PROJECT: Showboat Mixed-Used Development

CITY OF LAS VEGAS INTER-OFFICE MEMORANDUM		DATE: April 1, 2019
TO: Land Development Services Department of Building & Safety		FROM: Albert Sung, P.E. Flood Control Project Engineer Department of Public Works
SUBJECT:	Drainage Study for: Showboat Mixed-Used Development	COPIES TO: Lochsa Engineering
Cross Streets:	NWC of Fremont Street & Oakey Boulevard	Bentar Development
File Number:	F:\Depot\DSMemos\DS5085B.doc	Bart Anderson, P.E., DevCo
Parcel Number:	162-01-201-006, 162-01-201-007, 162-01-201-008	CCRFCD
Zoning Action:	SDR-74657; SUP-74656 & SUP-74781	CCPW
FEMA Flood Zone	YES NO X	NDOT
Proposed Storm Drain	YES NO X

Addendum to Technical Drainage Study for Showboat Mixed-Used Development

COMMENT LETTER

SHEET	TITLE
PROJECT No.: 181085	
DATE: 1/8/2019	
SCALE:	
DRAWN BY: NTS	
DESIGNED BY: BDA	
CHECKED BY: BDA	
KM	
SHEET No. C7.04	
SHEET 58 OF 61	
HTE No.

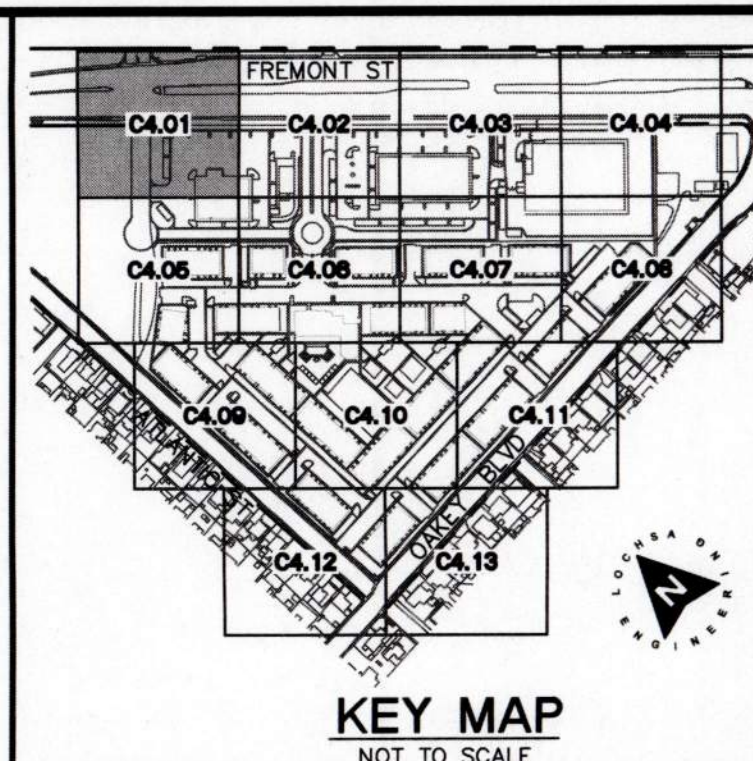
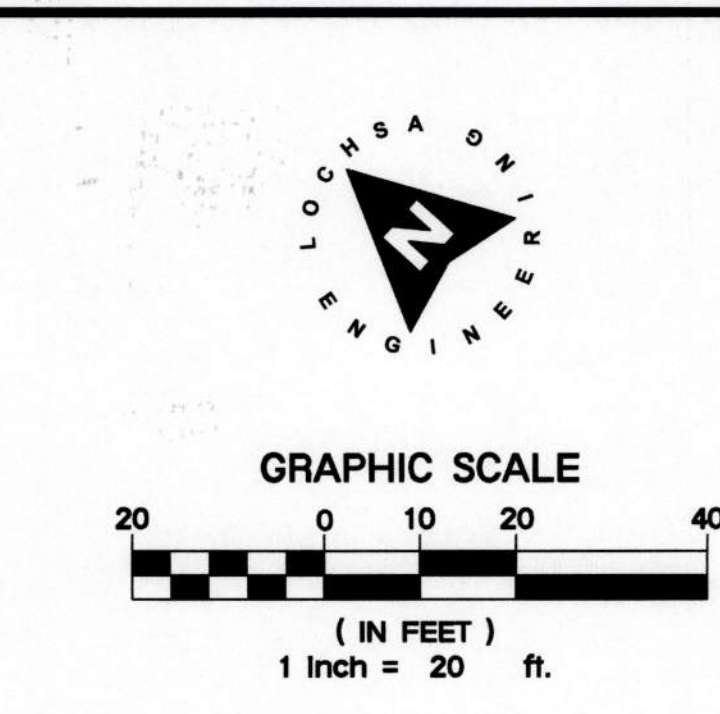
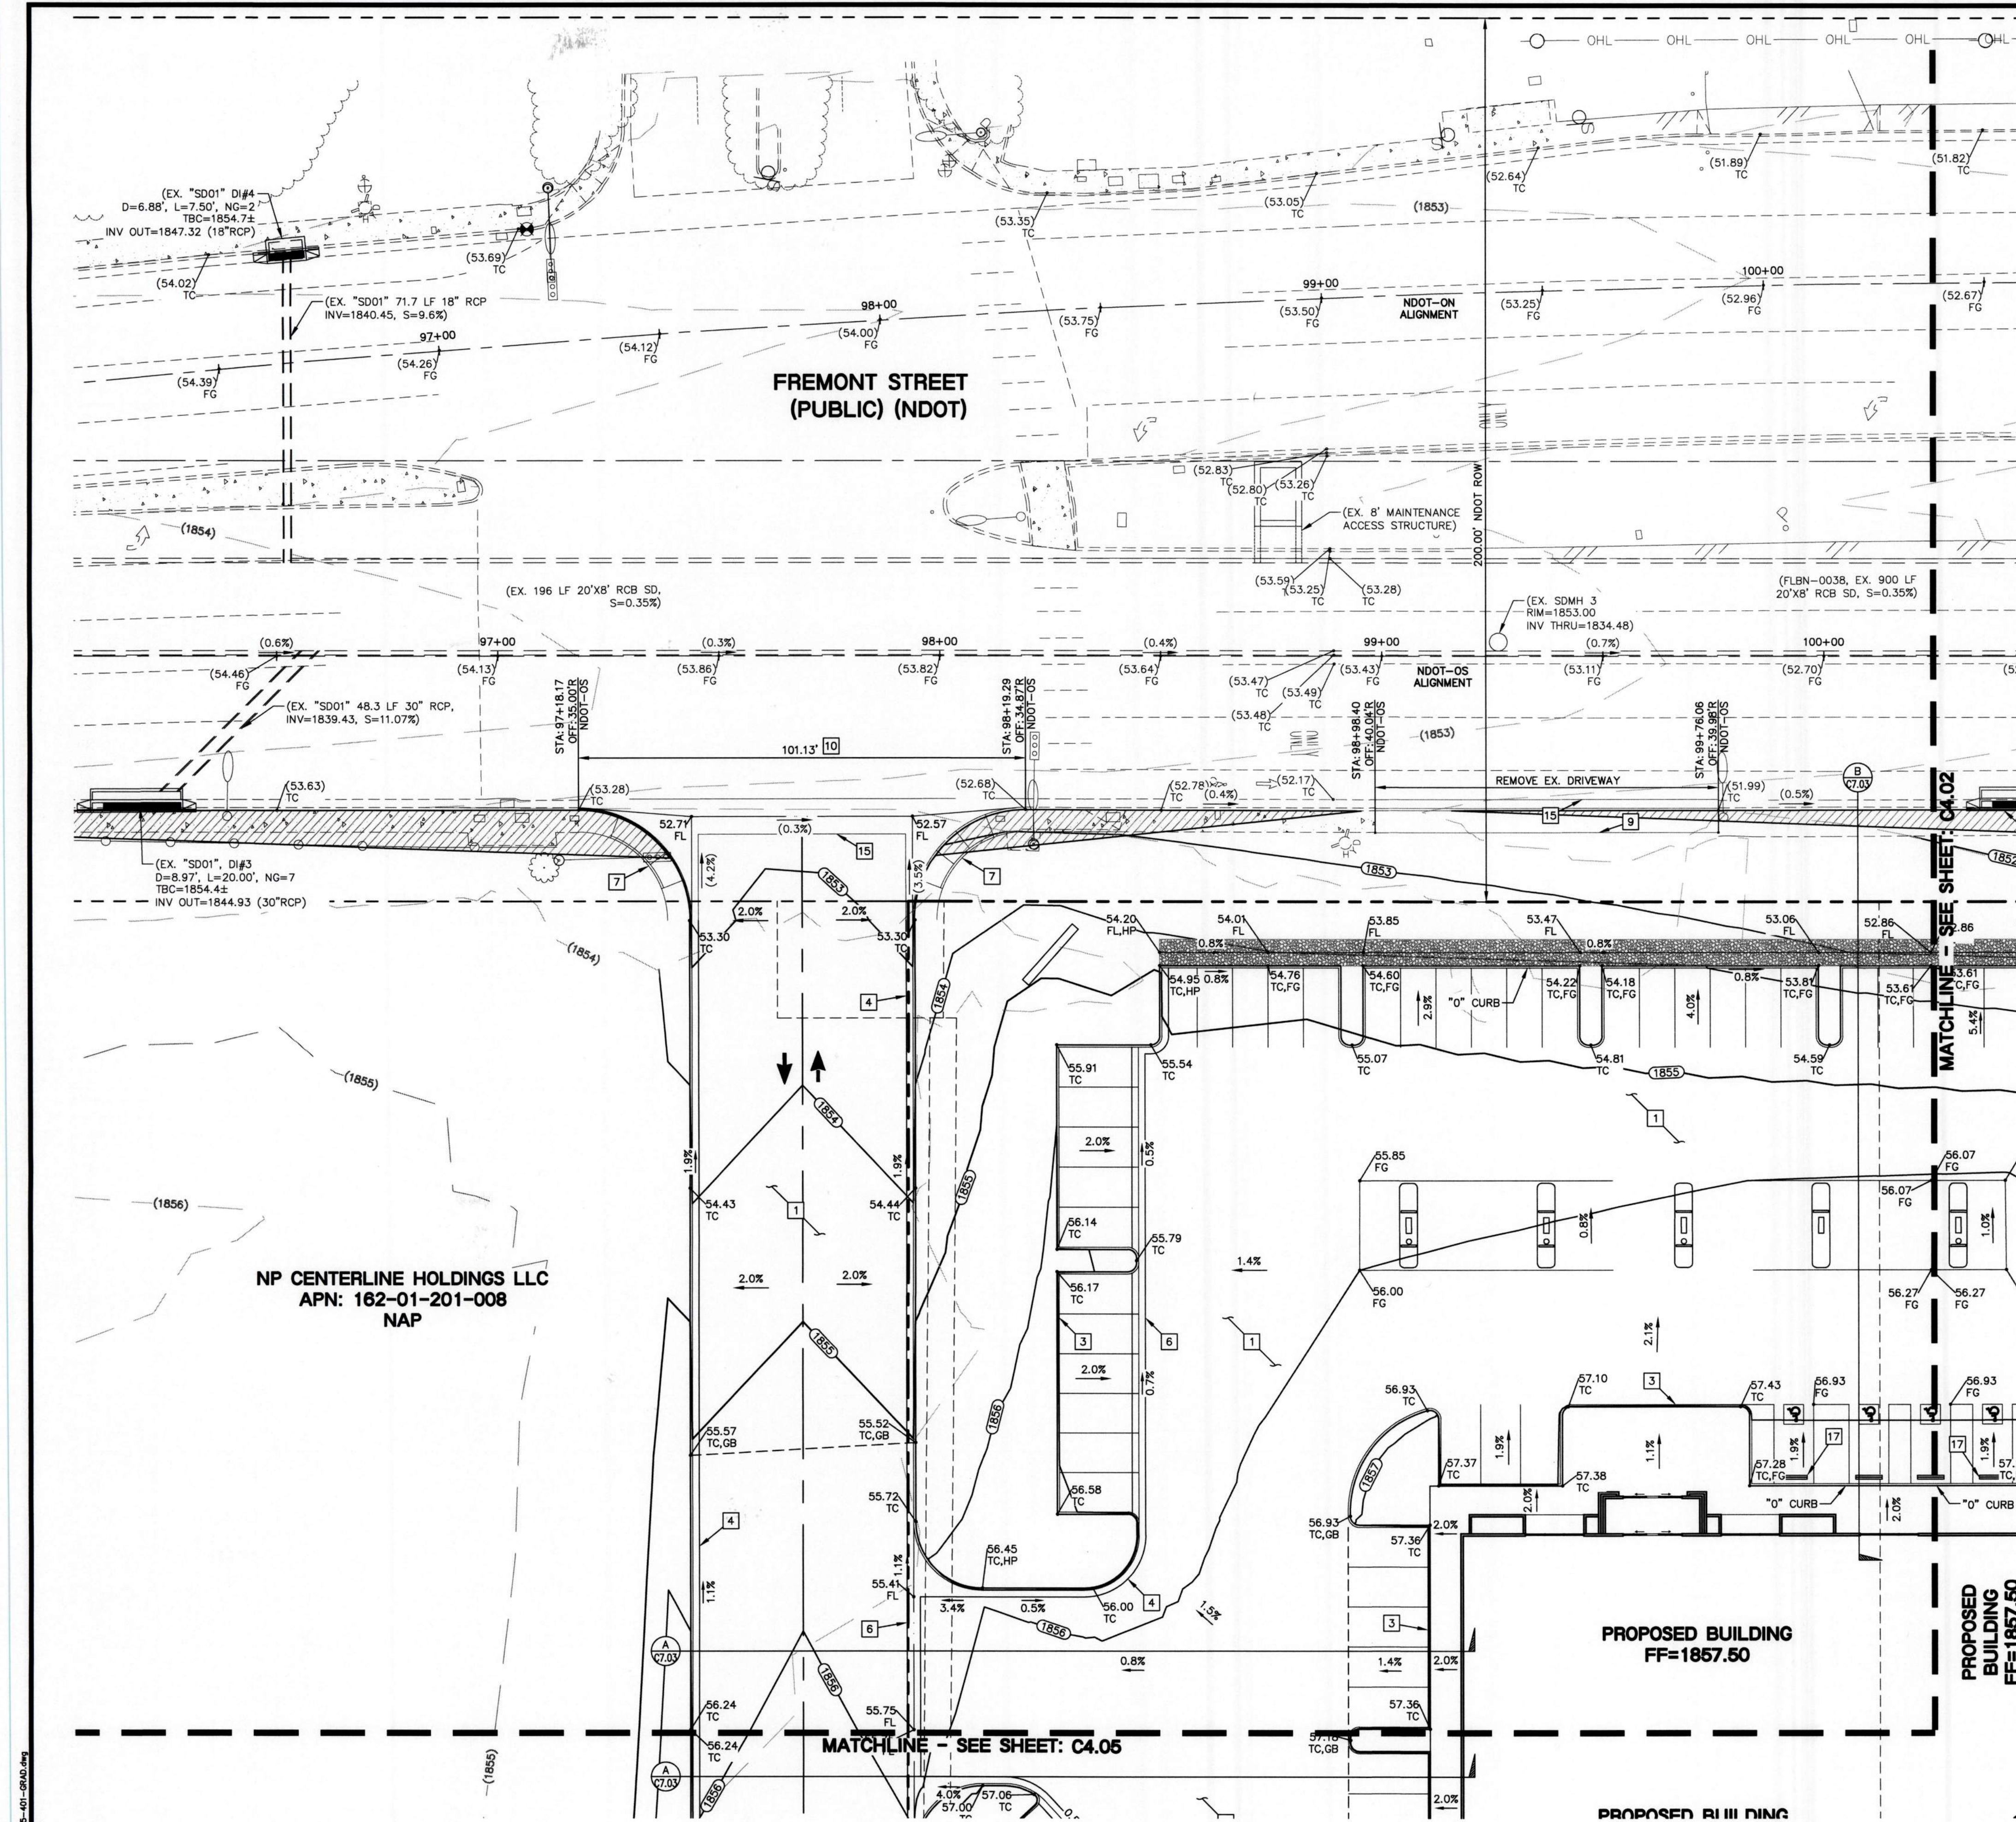
4. The subject project is adjacent to an ongoing capital improvement project in *Fremont Street*, namely: "*Flamingo-Boulder Highway North – Boulder Hwy, Sahara to Charleston (Boulder Highway Storm Drain)*". The engineer should coordinate with Ms. Anita Marquez, Engineering Project Manager at the *City of Las Vegas Public Works Department* for guidance on boundary conditions. Obtain Ms. Marquez's approval of boundary conditions along *Fremont Street* prior to the final approval of the subject drainage study.
5. The minimum size for riprap along public streets are $d_{50} = 8"$. Revise **Section Detail V/C7.04** to show $d_{50} = 8"$ with thickness equal to 16".

SHEET No. C4.01

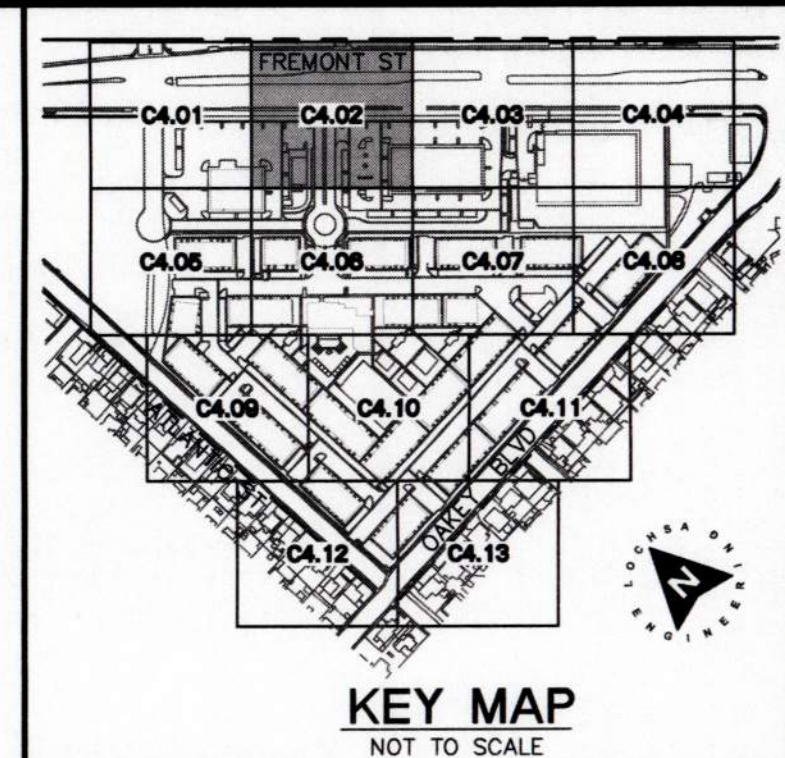
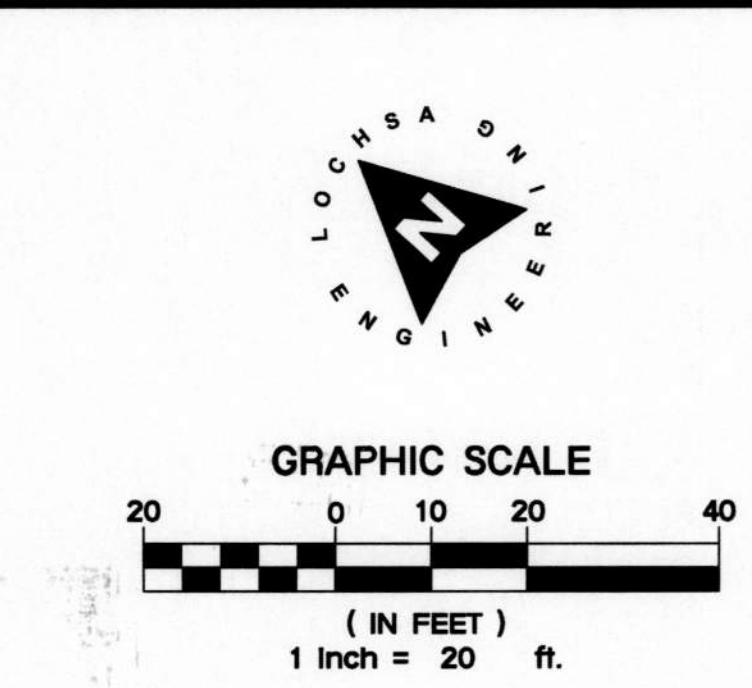
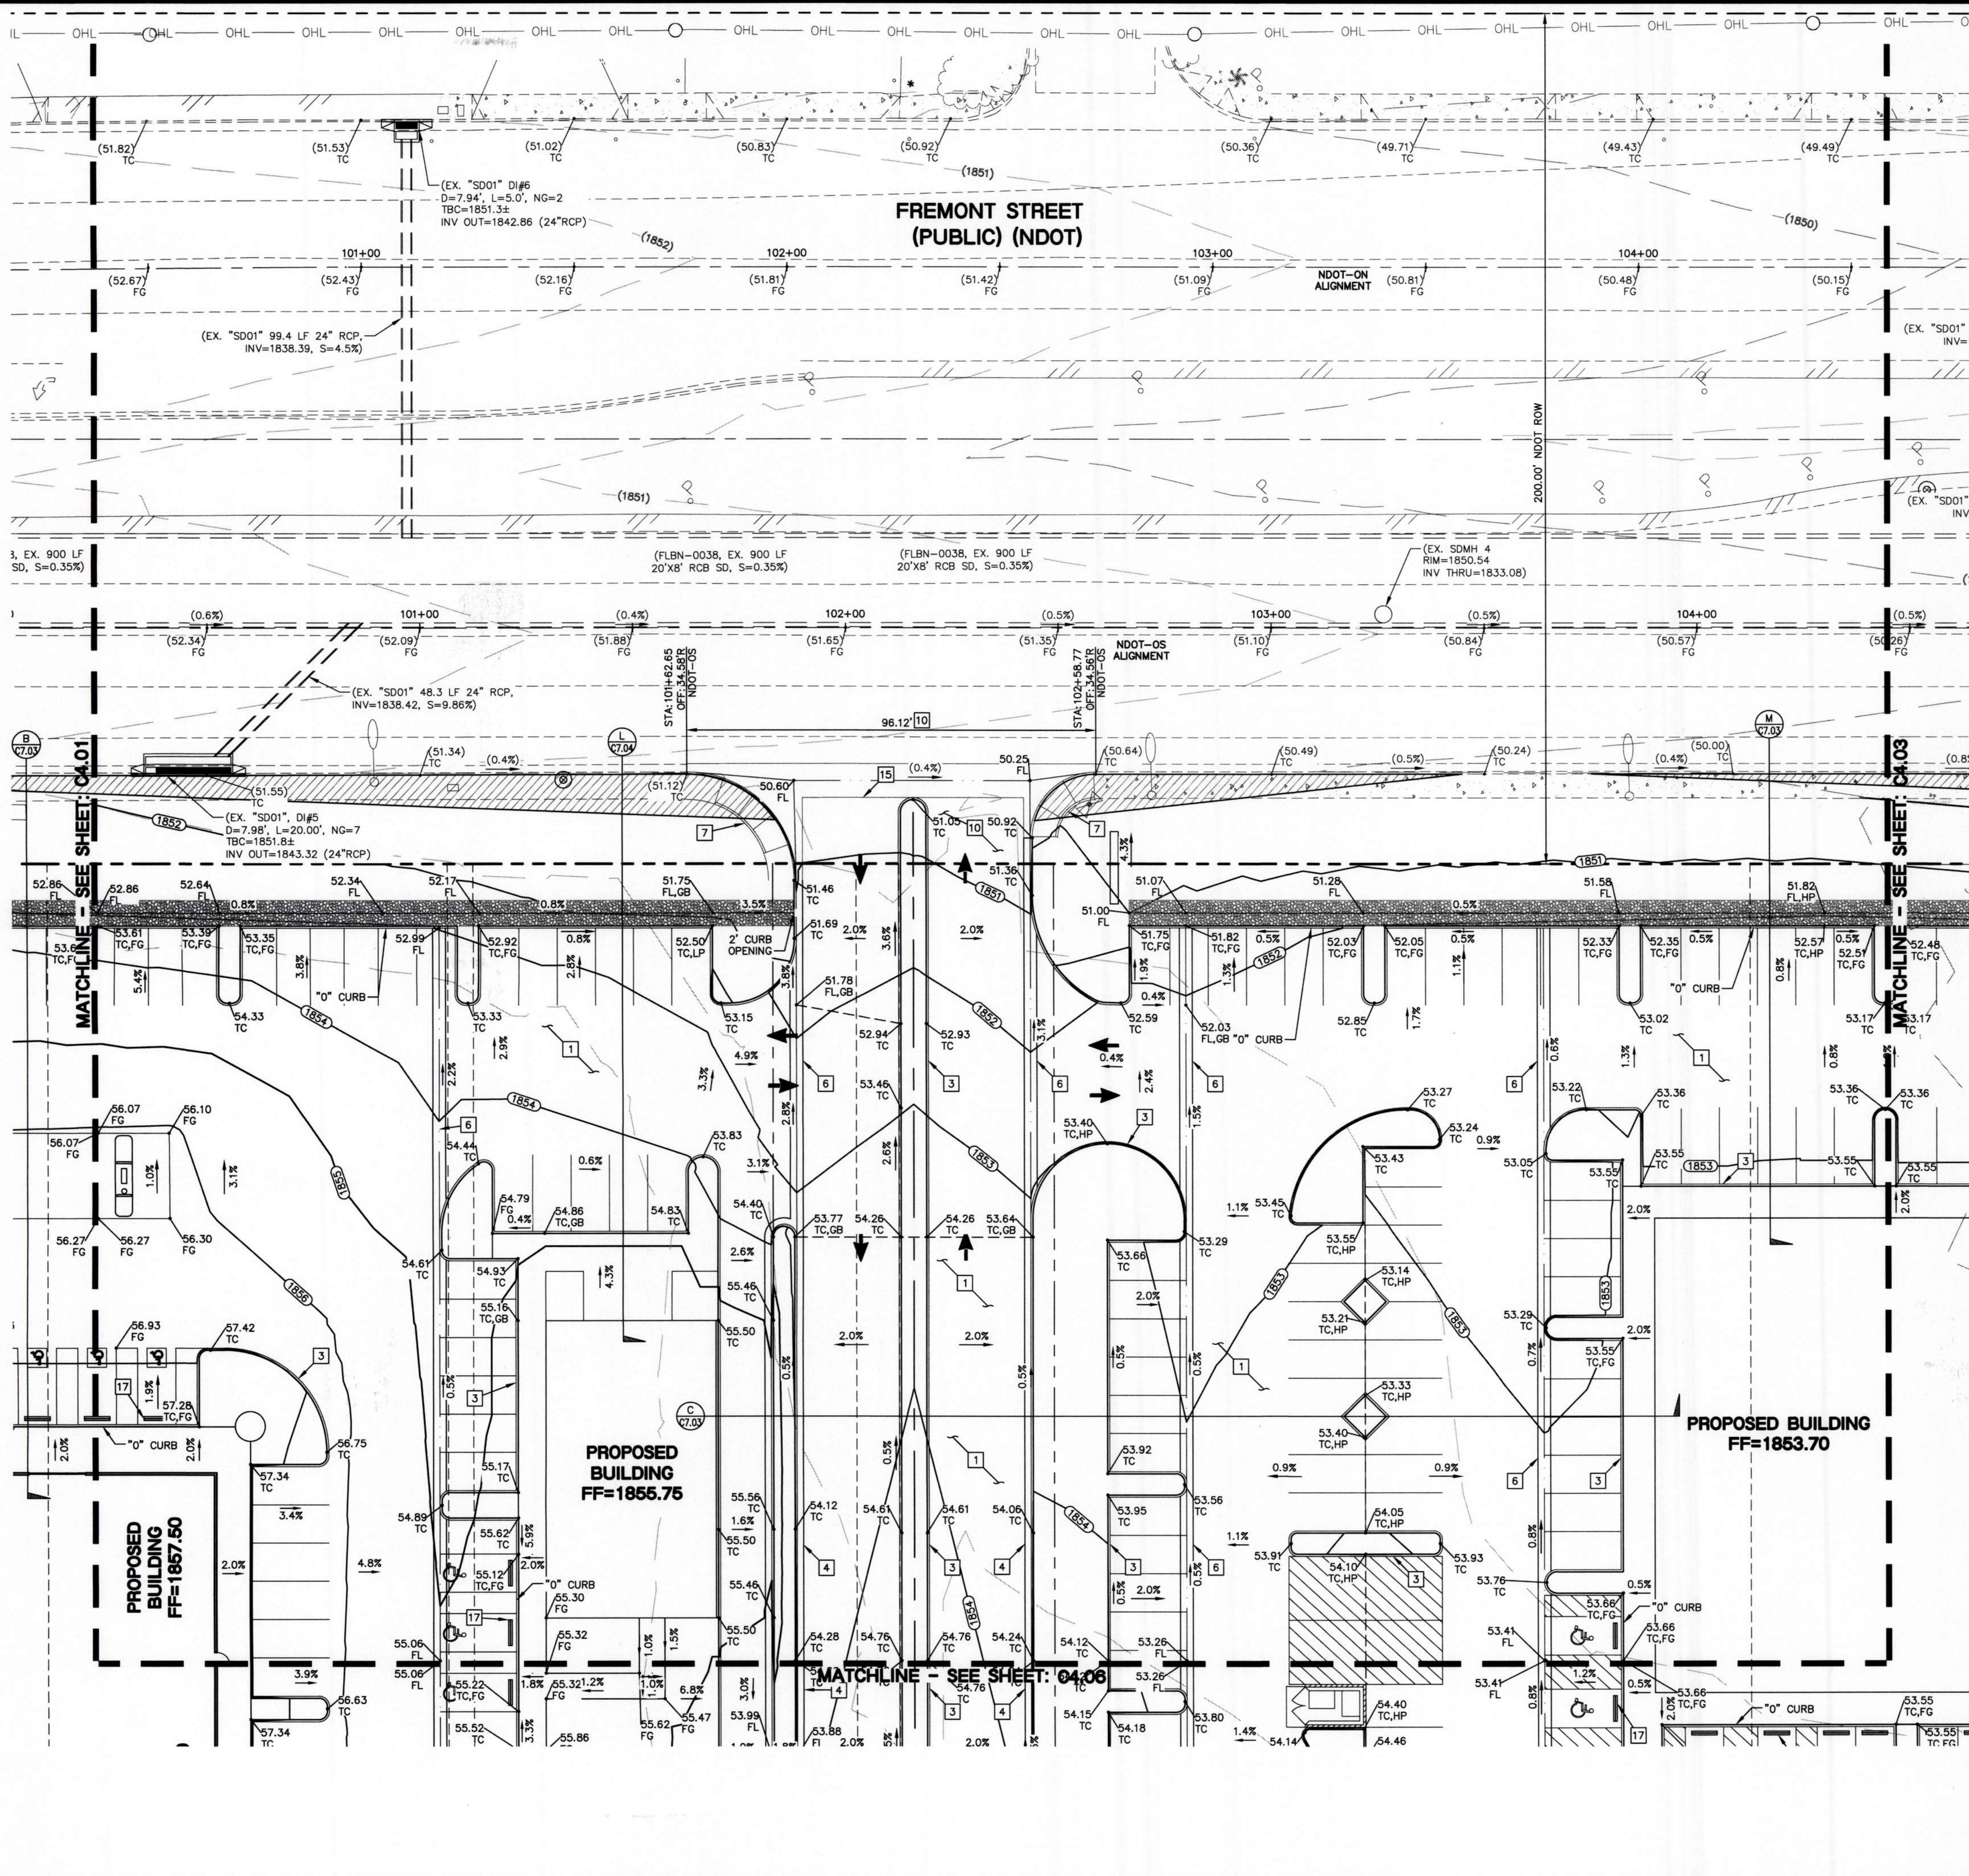
8. **Sheets C4.01 & C4.02:** It appears that the handicapped parking stalls at the north side of the proposed building is draining towards the building instead of away from. Review and revise accordingly.

Response 8: It appears we did not label the grades accurately along the building. They should have been shown as TC/FG (top of curb/finish grade). The plans (C4.01 & C4.02) have been revised to make it clear and show that there is positive drainage away from the building.
